ACP ref: 322154-25

Re: Response to Further Information Request in relation to An Coimisiún Pleanála Ref. 322154-25, for the Proposed Briskalagh Renewable Energy Development, Co. Kilkenny.

Response to Further Information

**ADDITIONAL AND AMENDED
PLANS AND DETAILED
DRAWINGS**

Plate 26 WC7 Stone Arch Bridge - Dense Vegetation cover

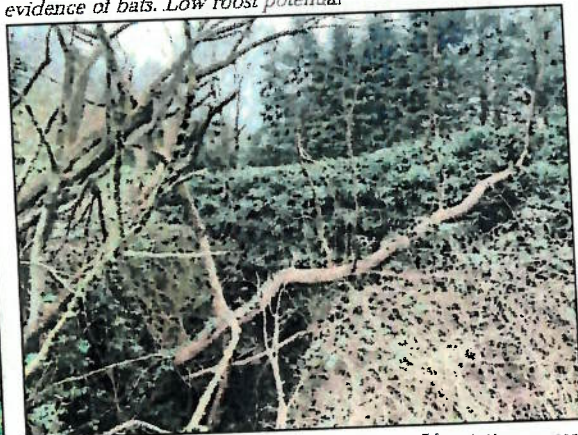
It is noted that there are potential roosting features present within a number of the bridges along the proposed grid connection route (as per Appendix 6-2 of the EIAR). A combination of flatbed formation and horizontal directional drilling are proposed at these bridges. Notwithstanding the Applicant's response in their grounds of appeal, the level of noise and vibration associated with the proposed works is unclear. Uncertainty therefore remains regarding the potential impact of the works on roosting bats and whether a derogation may be required. In this regard, the Applicant is requested to respond to this matter.

Plate 27 WC7 Small gaps and crevices underneath dense vegetation. No evidence of bats. Low roost potential

Drawing Title		Project Title	
Briskalagh Renewable Energy Development		Briskalagh Renewable Energy Development	
Drawn By	MC	Checked By	EMC
Project No.	230502	Drawing No.	Figure 6
Scale	1:125,000	Date	2024-09-20

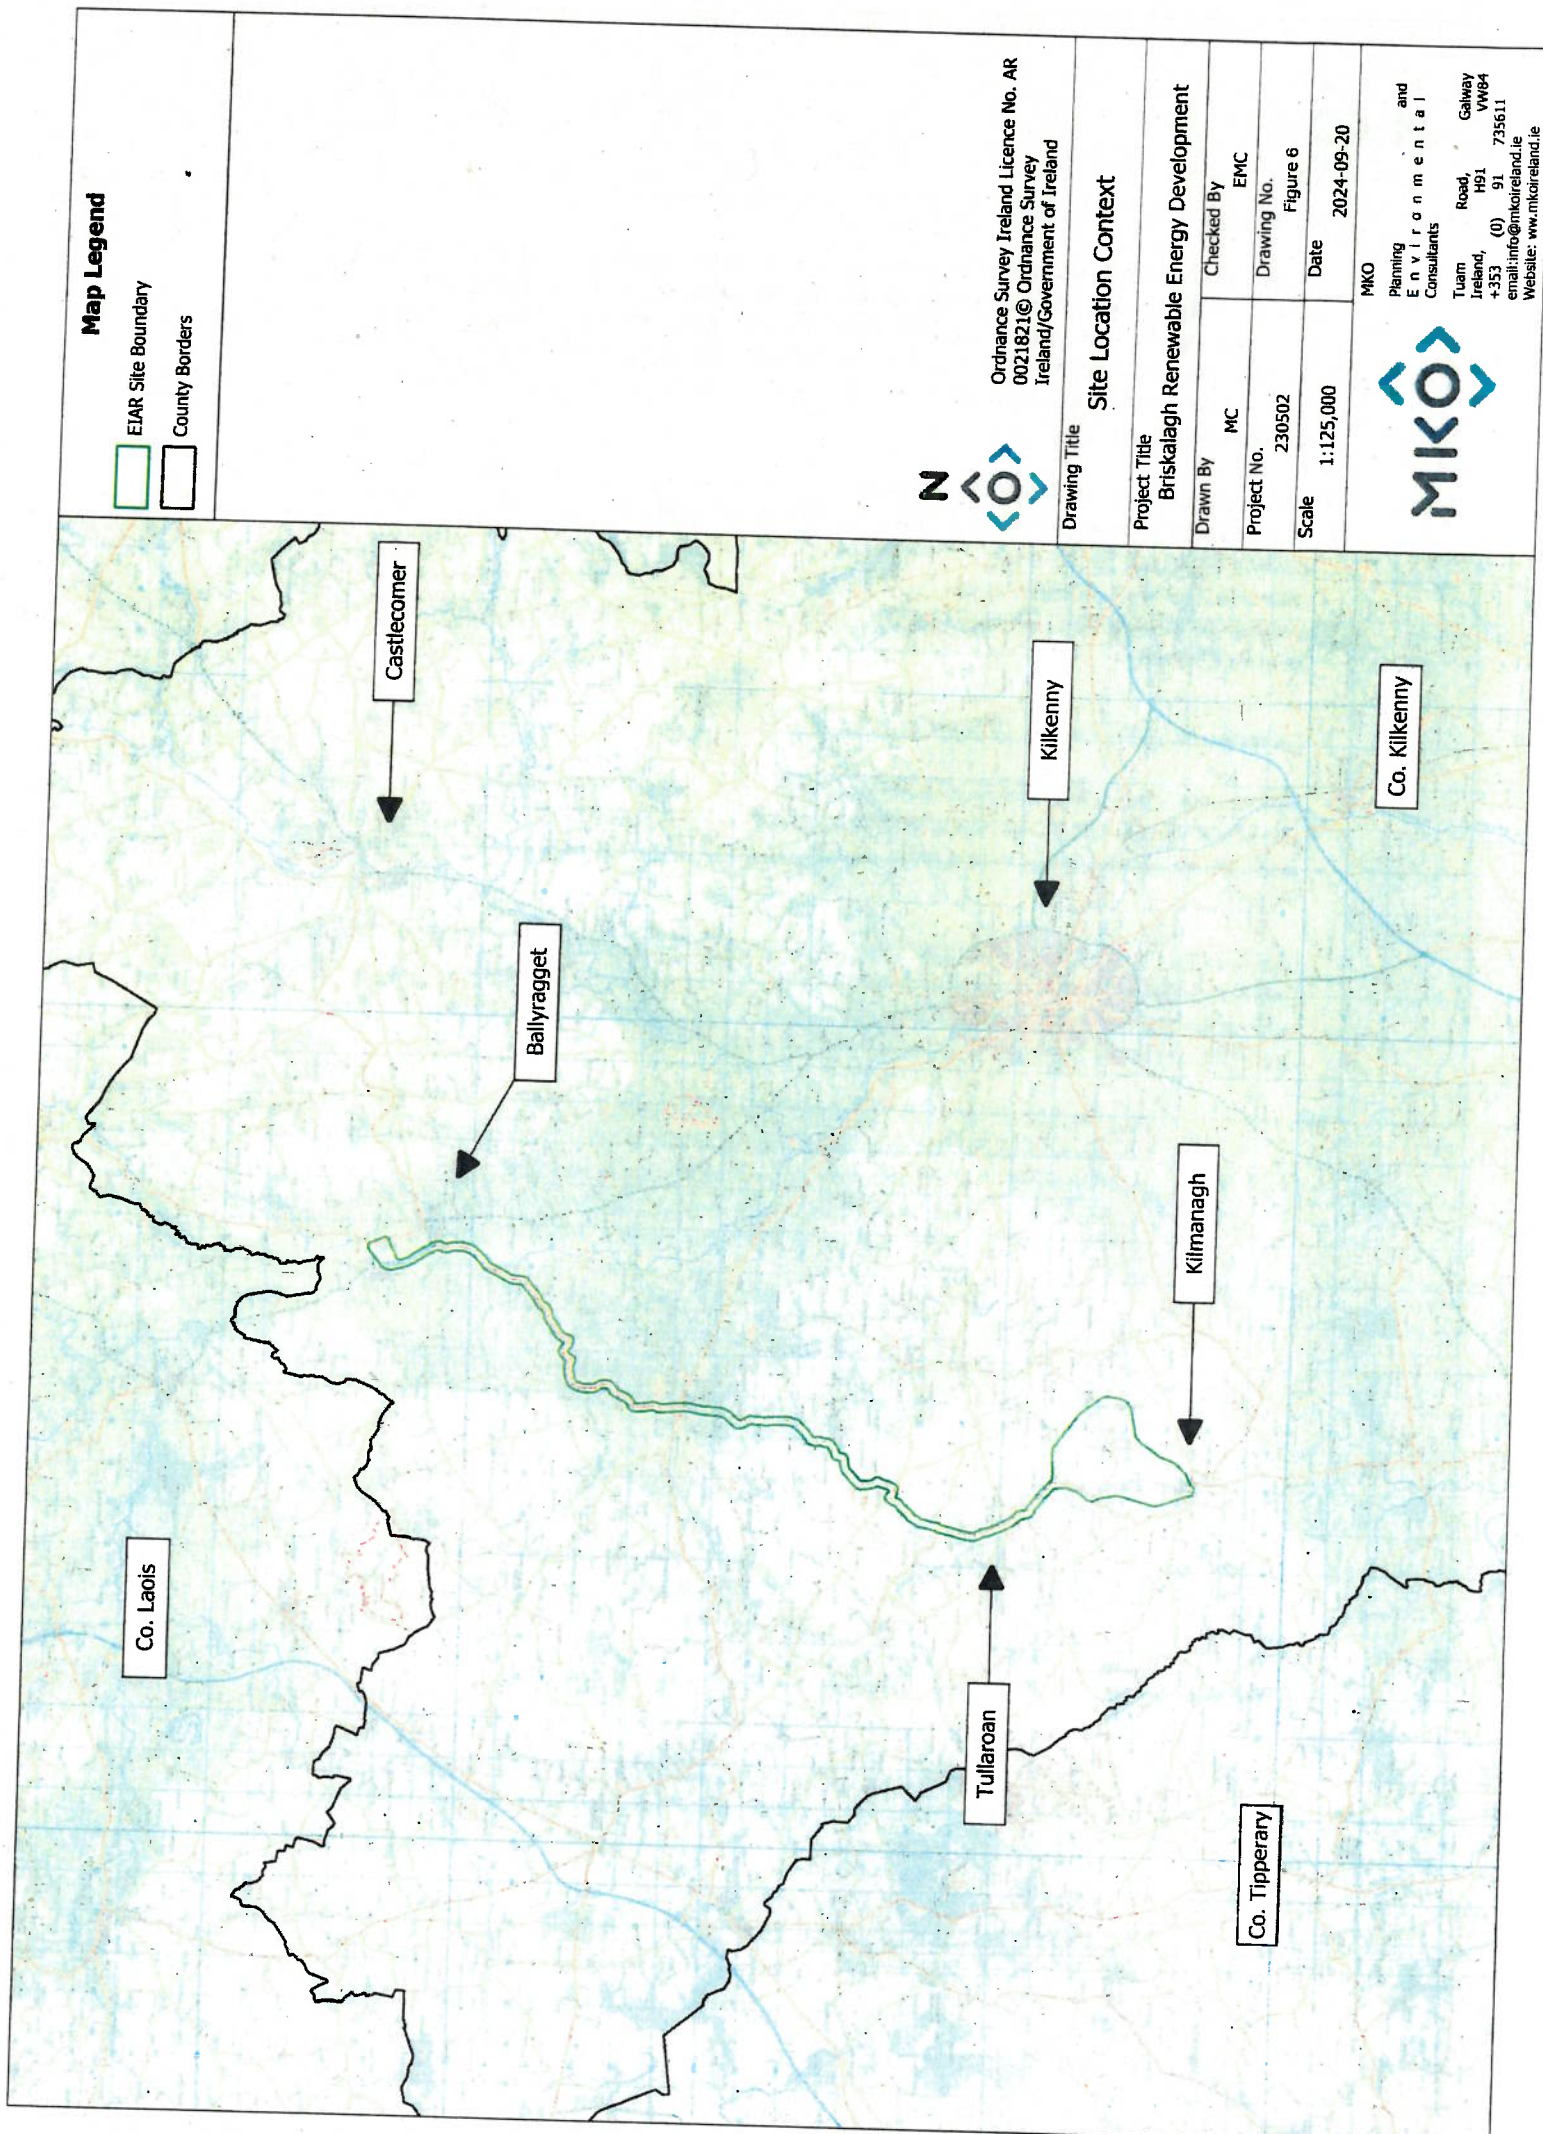
Figure 1-1 – Site Location Context was erroneously omitted from Chapter 1 of the EIAR. This has now been included as Figure 6 below.

Project Title	Checked By	CM
Drawn By	FK	CM
Project No	230502	Figure 7
Scale	1:246,100	Date
		08.10.2024

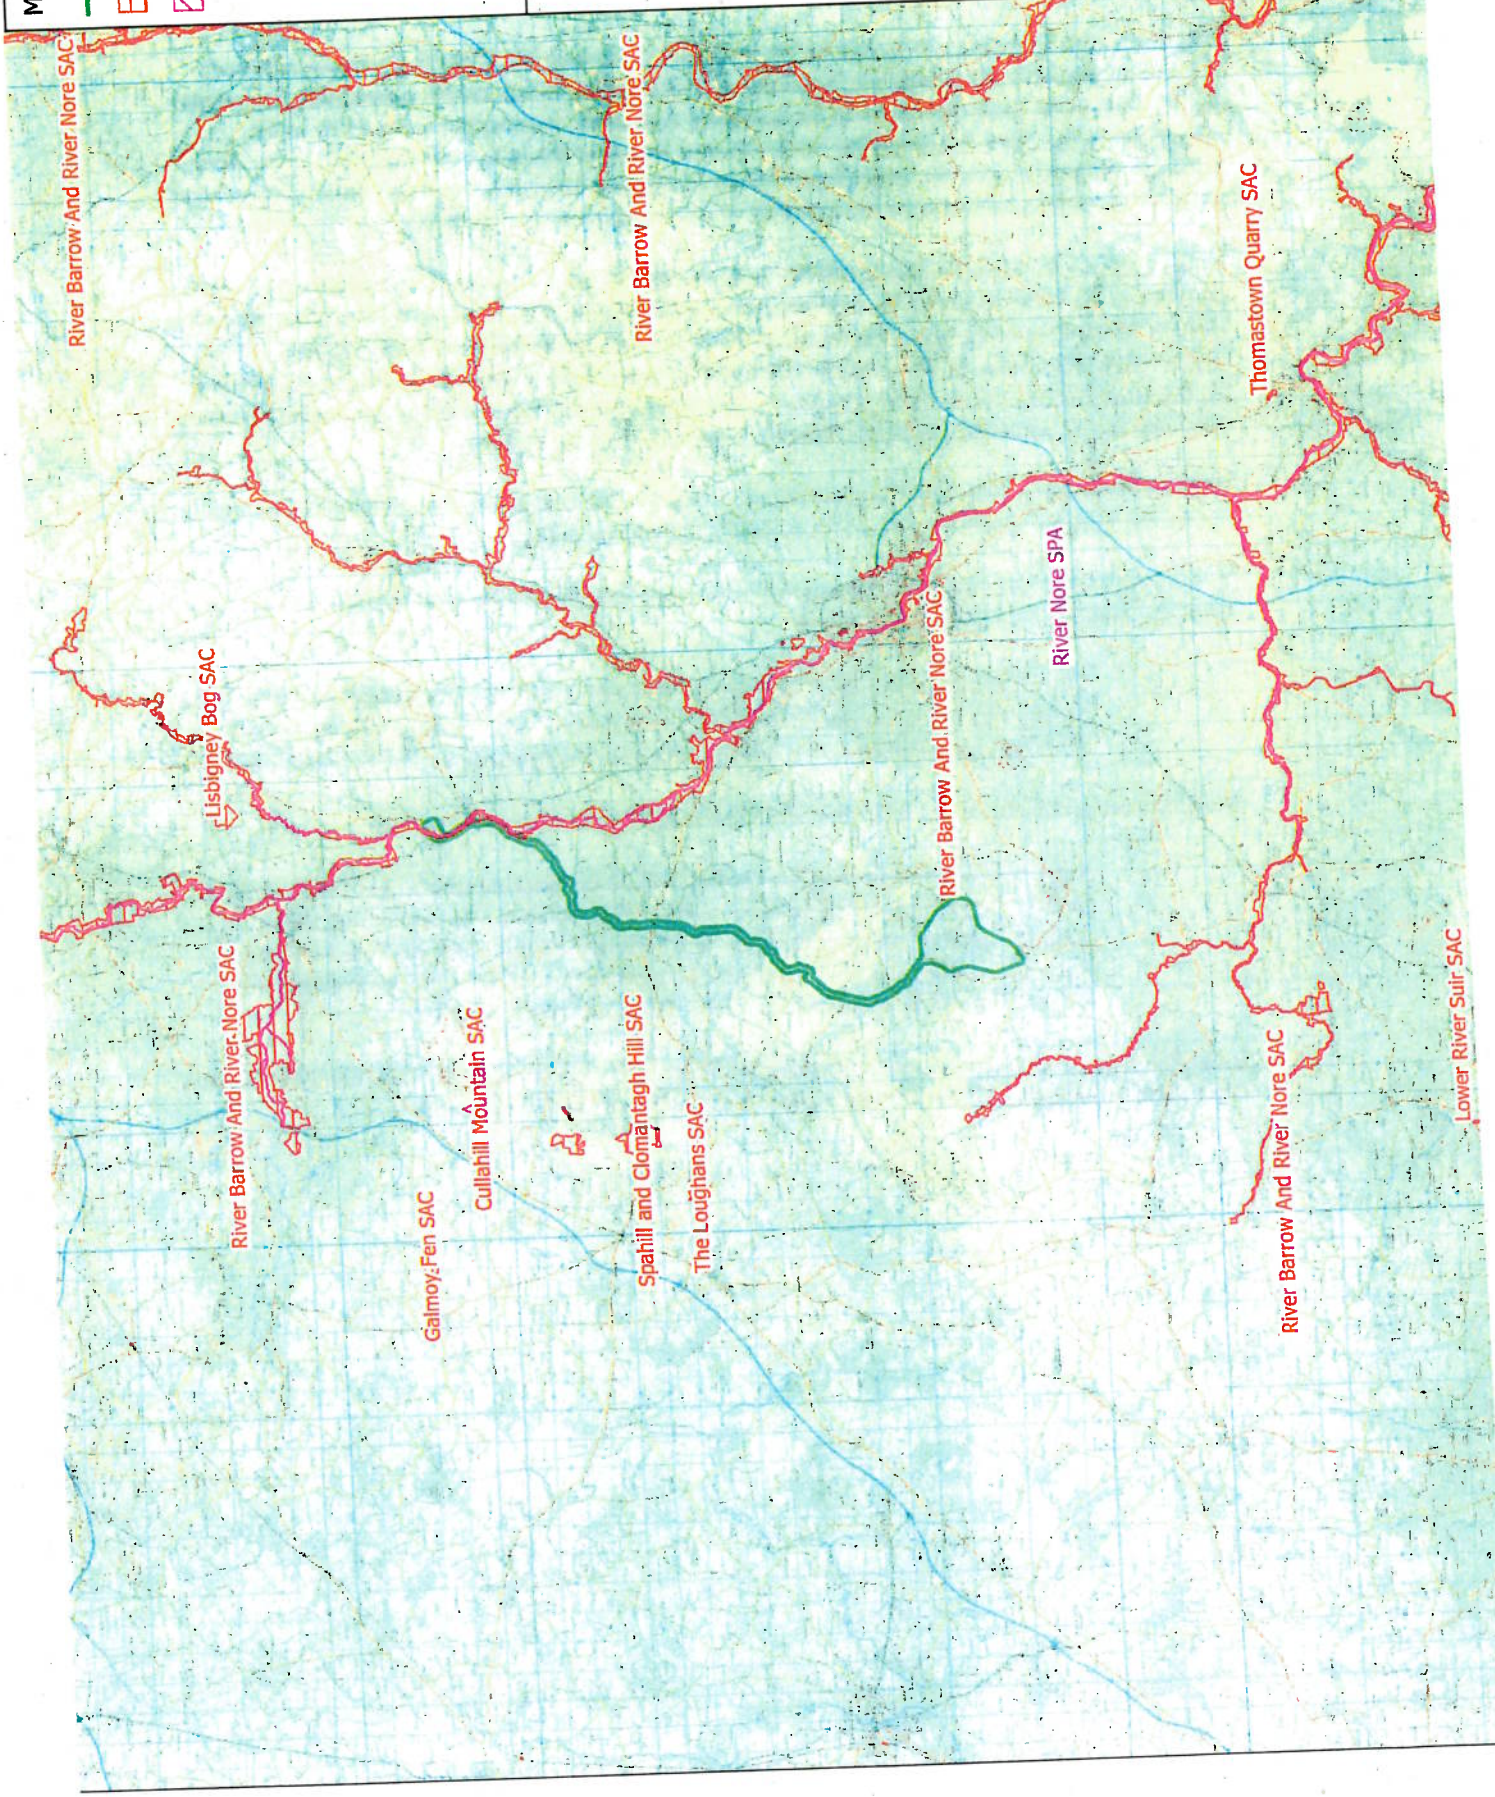
It should firstly be highlighted that Figure 3-1 of the Appeal Document contained incorrect site boundaries and legend references. The correct figure has been included below (See Figure 7). A summary on updated surveys and findings has been provided below, but has also been discussed in Section 2.7.3.1.1.

PROJECT TITLE		Briskeagh Appeal - Further Information Response	
DRAWING TITLE		Proposed Grid Connection Watercourse Crossing 02	
PROJECT No.	DRAWING No.	SCALE	AS SHOWN @ A3
231502 - R	231502 - R01	231502 - R01	
DRAWN BY	CHECKED BY	DATE	REVISION
GO	N/A	23.10.2025	F01

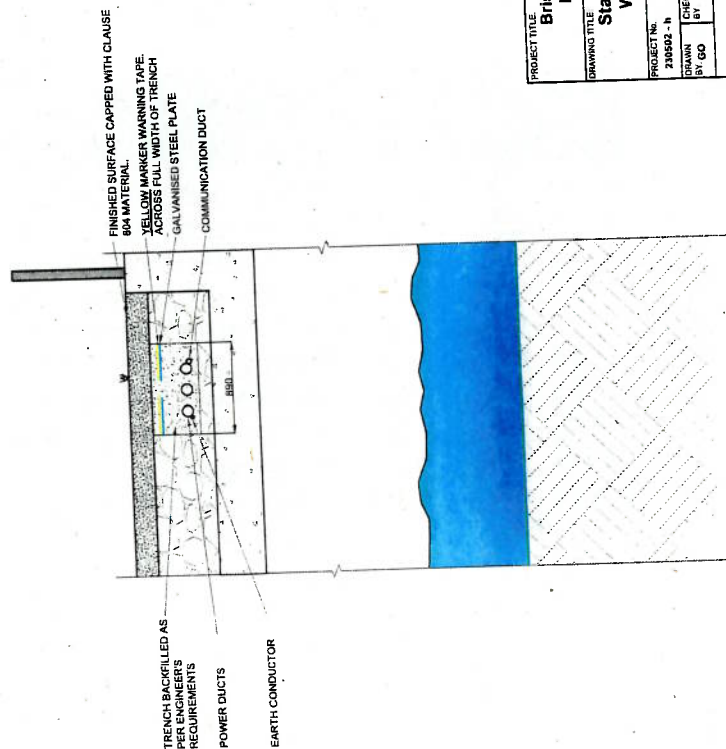
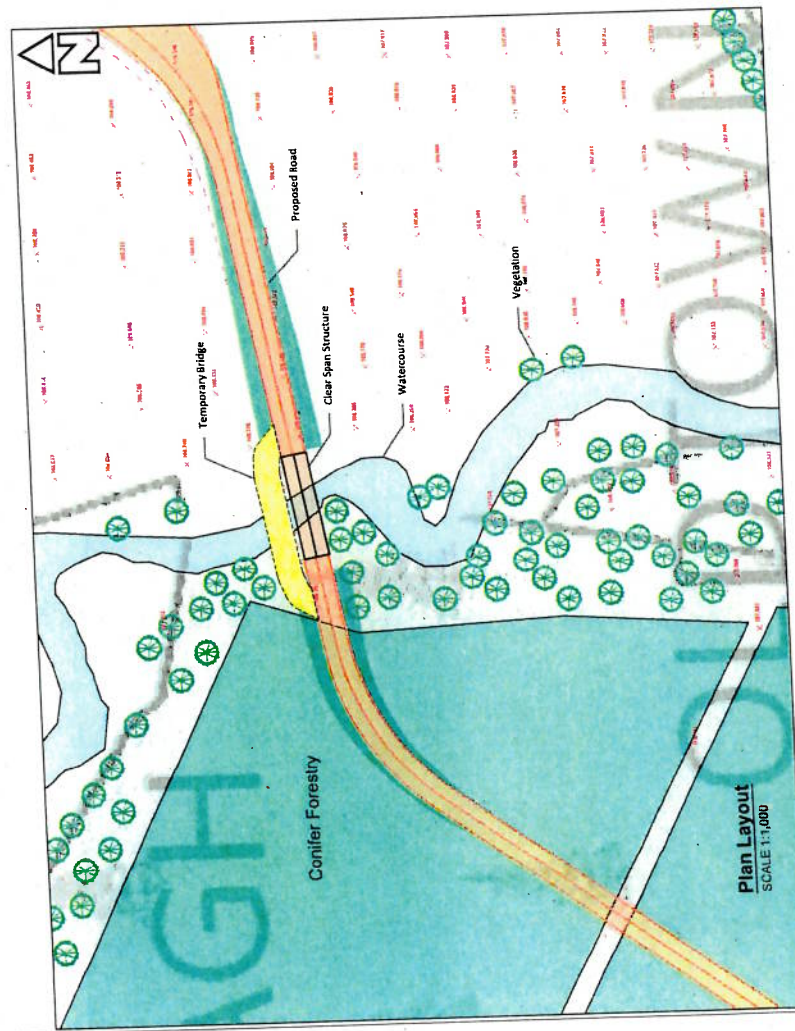
You are requested to submit a site-specific plan and section diagram of the bridge crossing over the Tullaroan Stream between T6 and T7. The plan and section diagram shall include spot levels for the riverbed and banks and shall clearly illustrate the relationship between the proposed clearspan bridge and the new access roads on either side of the watercourse. The plan shall also include details of the relevant mitigation measures required for the protection of water quality.

Please see drawing 230502-52FI of Appendix 2 for a plan and section diagram of the clearspan crossing over the Tullaroan stream.

PROJECT NO.	DRAWING NO.	SCALE
230502 - N	230502 - 61F1	As Shown @ A3
DRAWN BY: GD	CHECKED BY: N/A	DATE: 23.10.2025
		REVISION: F(01)

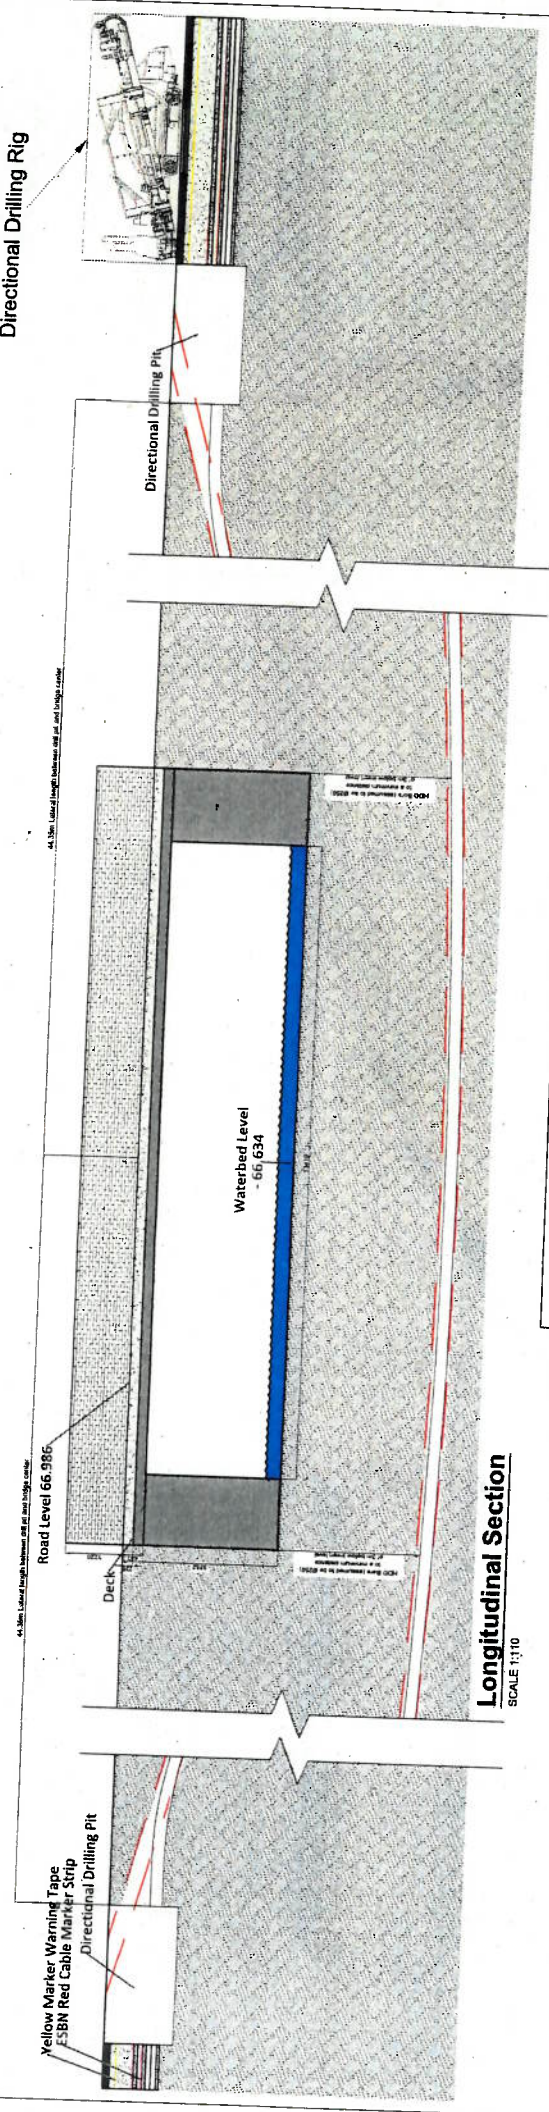
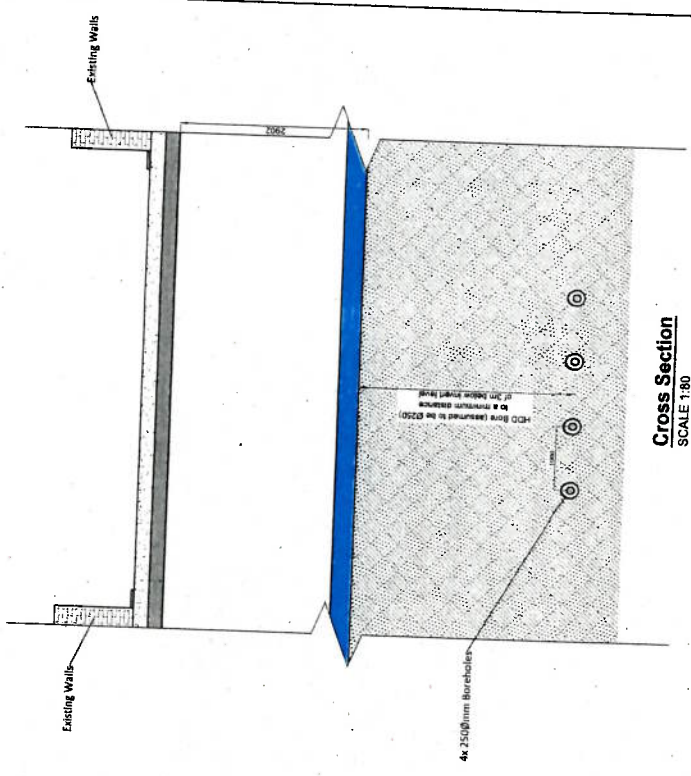
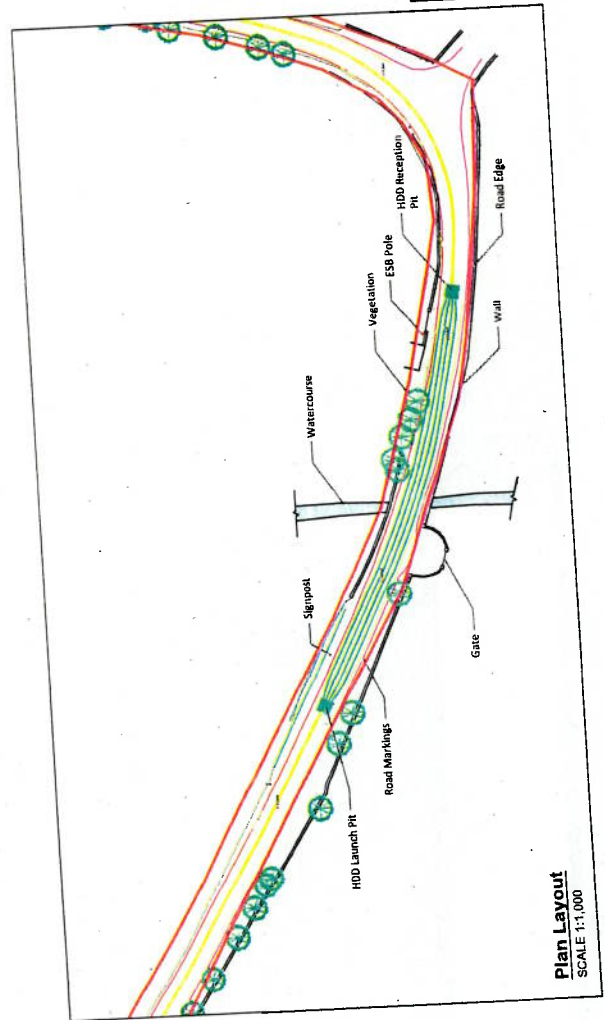
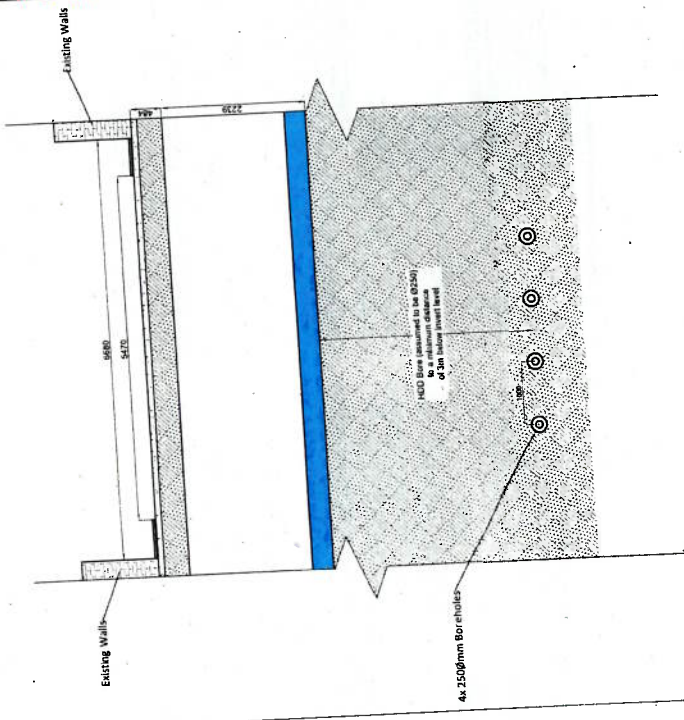
Concerns have been raised by the Planning Authority's Conservation Officer regarding the potential impact of the works on the various historic bridges along the proposed grid connection route i.e. structural damage, insufficient road depth to accommodate the new cables and the potential requirement for heightened parapets due to road buildup. You are required to respond to this issue and put forward proposals for HDD at bridges both included on the Record of Protected Structures (RPS Ref. C886)(WC6) and the National Inventory of Architectural Heritage (NIAH Ref. Reg. 12305031(C886) and 12305012 (NewBridge)(WC5)) located within the urban centre of Freshford.

Additional Layout Plans for HDD at WC5 and WC6 have been included as part of this RFI. Please see drawings 230502-62FI and 230502-77FI for the updated plans. As HDD crossings will be employed at these locations, there is no potential for direct negative impacts on both protected structures as the Proposed Grid Connection underground cabling will not directly interact with the bridge structures, instead drilling beneath the road surface. Therefore the findings of the EIAR (that no significant effects on bridge structures of cultural heritage significance) has not been altered.
